STAFF ANALYSIS FOR PLANNING COMMISSION

ASDP-9338-2022

Watkins Mill Town Center Urban Core

SUBJECT: Final Staff Analysis
ASDP-9338-2022: Watkins Mill Town Center Urban Core

Exhibit #36- Revised Site Plan

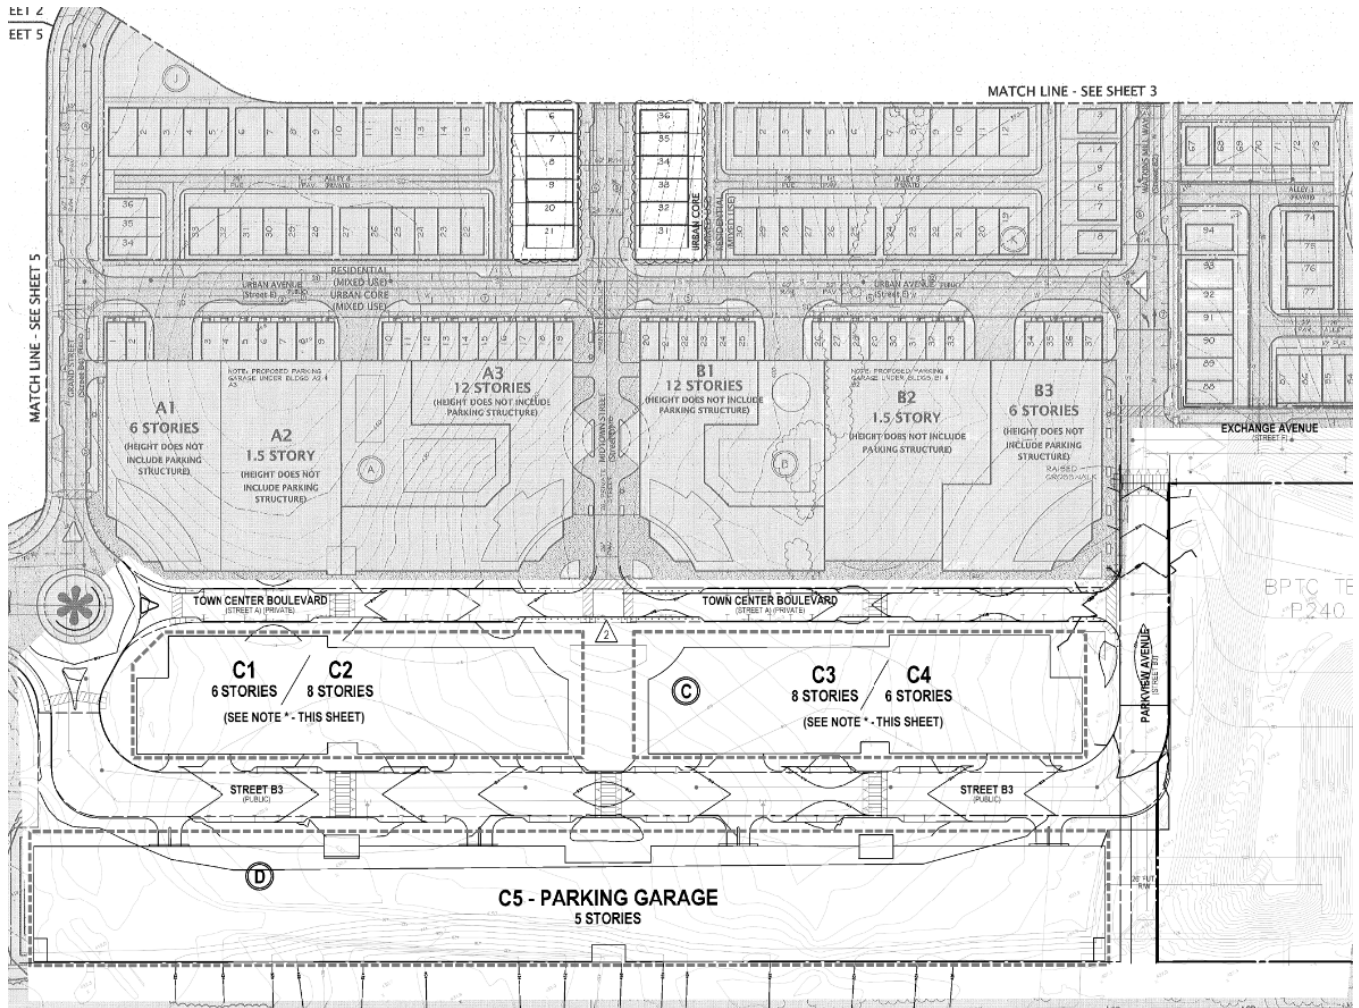
As mentioned above, the Applicant is requesting to reallocate 100,950 square feet of office density and 62,494 square feet of retail density between previously approved Buildings B1, B2, B3, C2, C3 and C5. Initially, the Applicant planned to construct Buildings C2 and C3 for a life sciences and biopharmaceutical office campus with integrated ground floor retail. The increase of the building footprints for C2 and C3 will eliminate Buildings C1 and C4. Buildings C2 and C3 will contain 357,200 square feet of office and 5,000 square feet of ground floor retail. To provide flexibility, the Applicant submitted revised plans which include an option to construct Buildings C1 and C4⁴. The revised plans include a building restriction line and note height restrictions for each building in compliance with Sketch Plan Z-297. The final building footprint will be determined at final site plan in conformance with either proposed option. This revision does not change the reallocation of office and retail density as proposed. The ground floor retail previously located within the new parking garage (C5) will be relocated within Buildings B1, B2 and B3. The amendment only proposes shifting density between the various blocks and buildings, and the overall total square footage approved for Watkins Mill Urban Core will remain constant.

Exhibit #34: Pedestrian Connection Exhibits

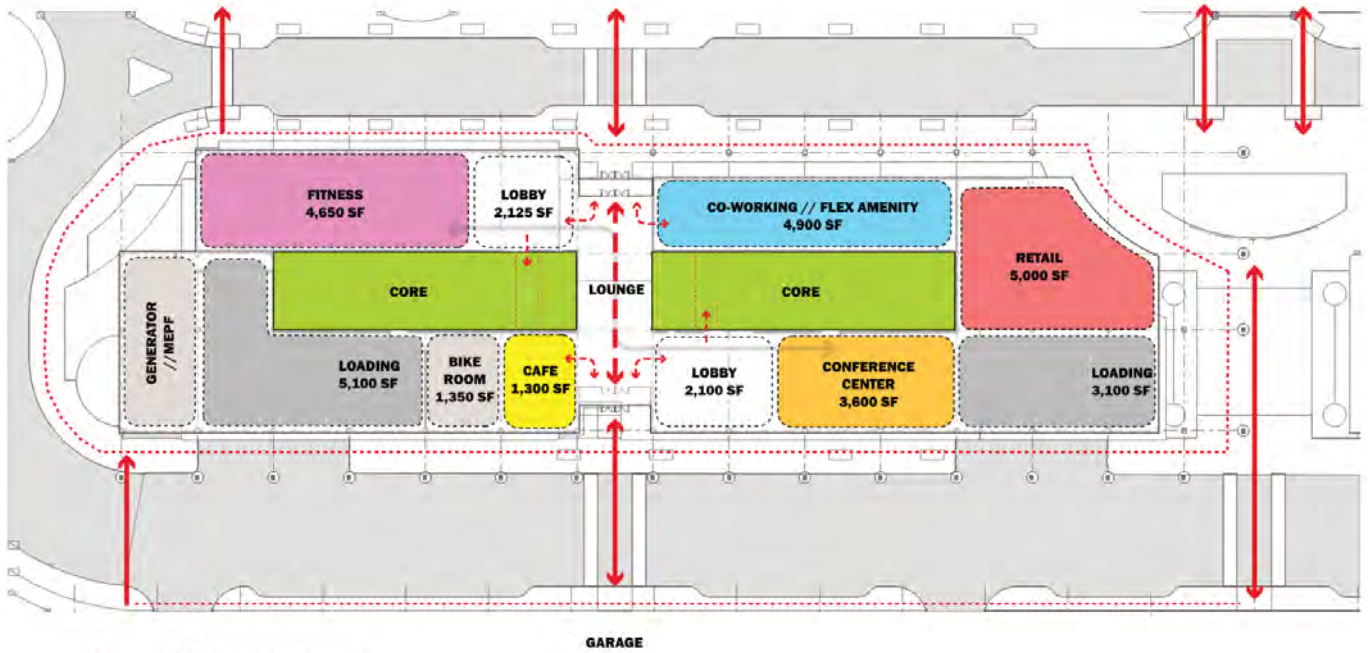
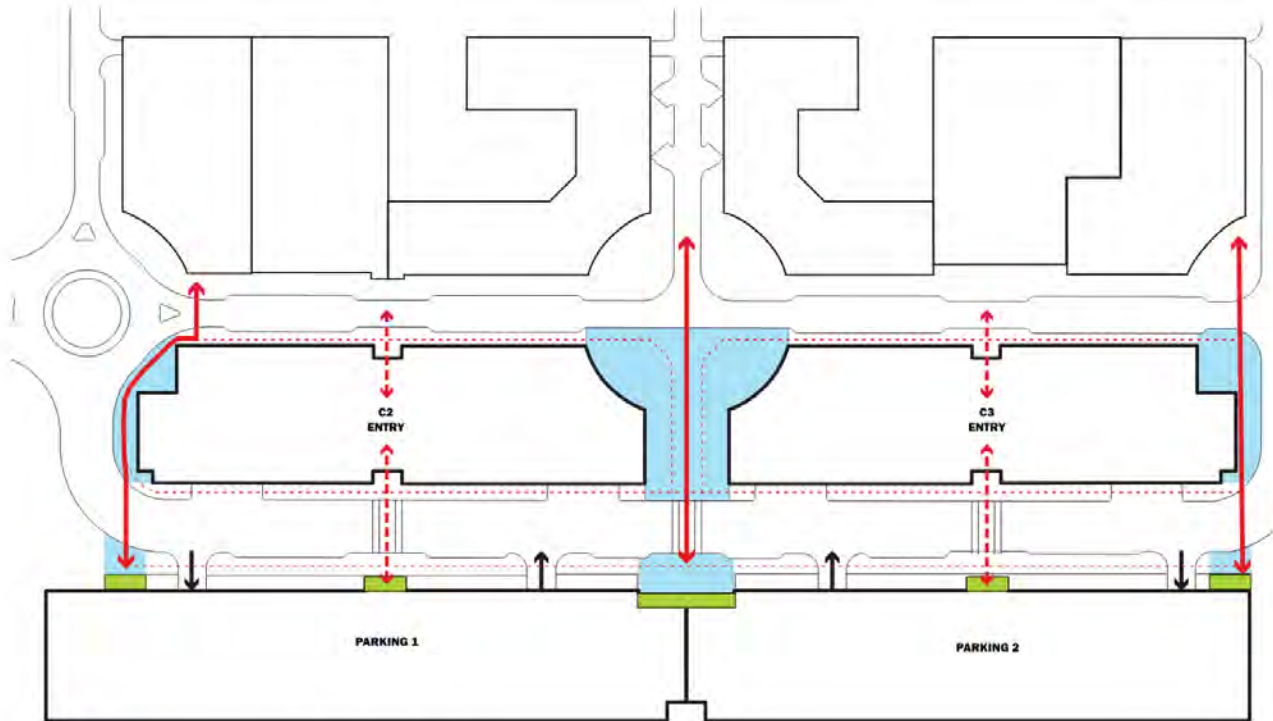
- Explore ways to provide breaks in the two buildings to provide a pedestrian connection to the garage and the rest of the urban core; and
- Elevate the pedestrian realm along the first twenty feet of the building.

To address comments raised about the pedestrian connections, the Applicant has provided an exhibit that shows a proposed pedestrian connection from the parking garage to the Urban Core⁵ (the pedestrian paths are shown in red). In the response letter, the Applicant notes one potential solution which includes a “pass through” lobby in both Buildings C2 and C3. At the center points of the buildings, pedestrians can enter through an interior connection passing through a public portion of the building lobby to access the remainder of the Urban Core. To emphasize the “pass through” locations and draw in pedestrian foot traffic, the buildings will be programmed with an exterior canopy at the pass through locations. In this scheme, a total of five access points will be programmed from the garage to the Urban Core. The number of connections will be consistent with previously approve Schematic Development Plan SDP-05-002.
